Cartwright Park, Fitzsimons Park, and Grey Park Improvements

RFP #24-61

ADDENDUM No. 1

November 13, 2024

CARTWRIGHT PARK
SCALE: 1"= 50'-0"

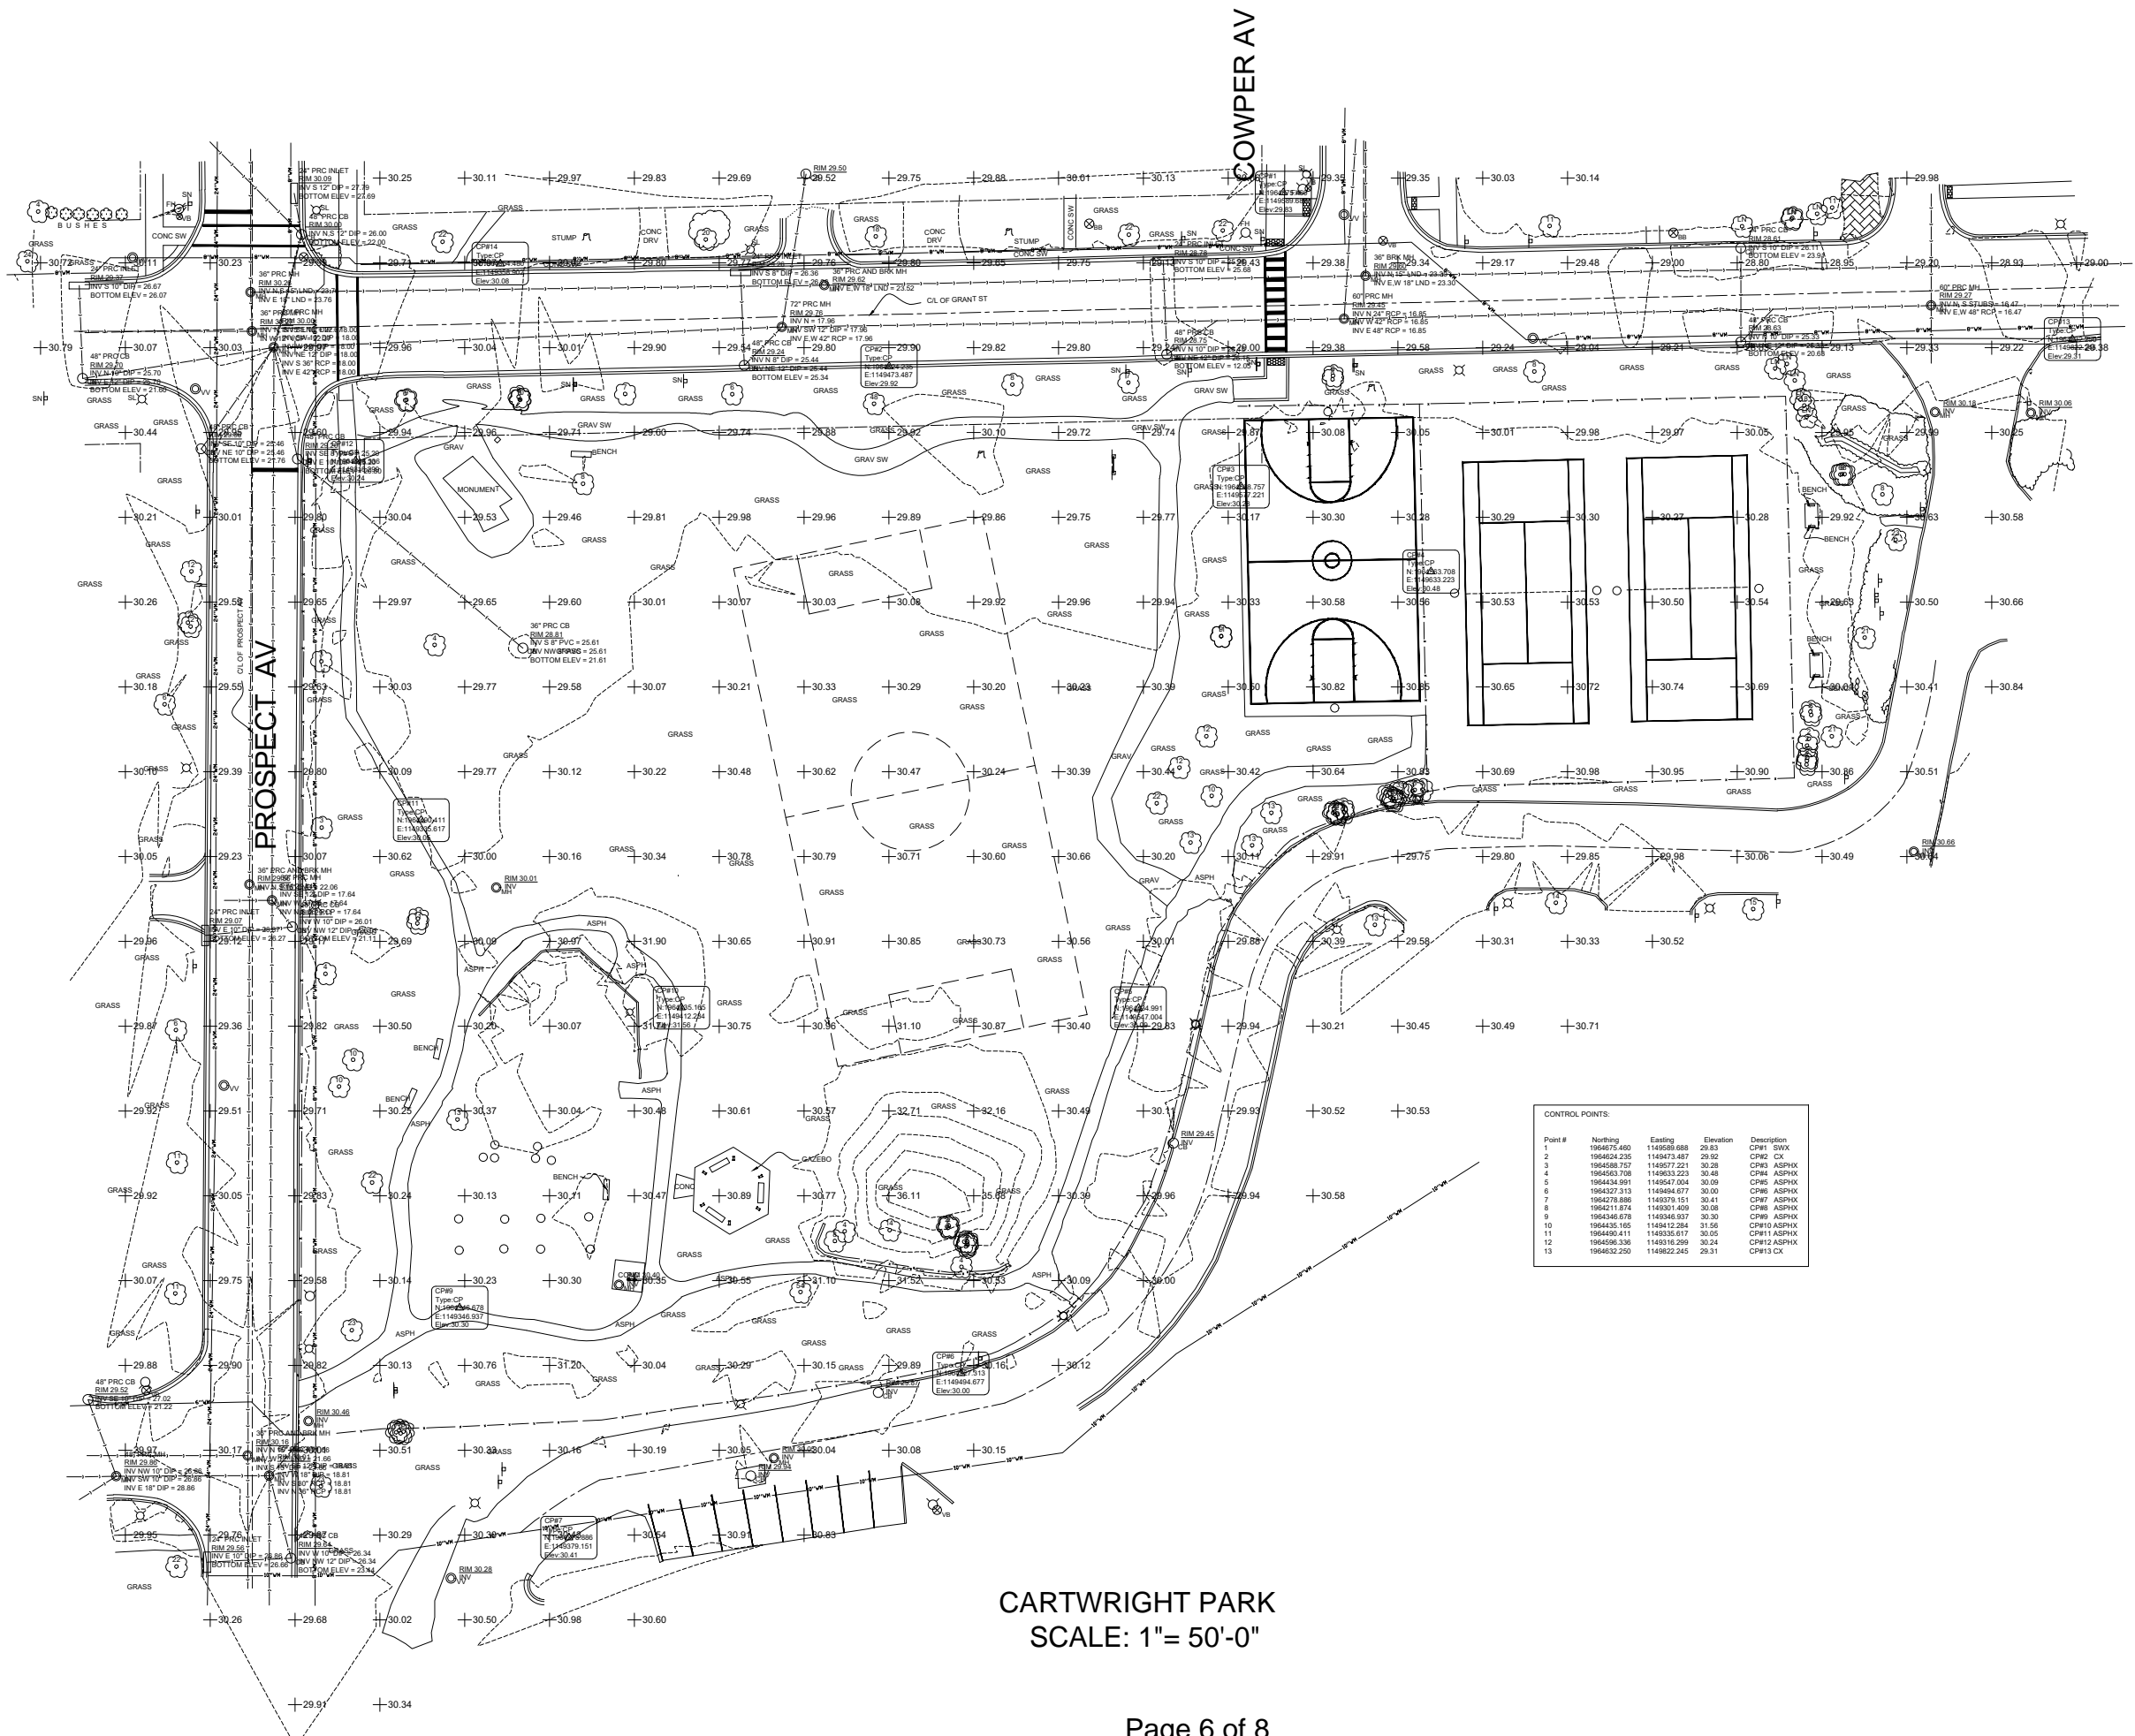
Question: Can the (3) Plats of Topography be made available that we can determine whether supplemental surveys are required?

Response: PDF copies of the Plats of Topography are attached.
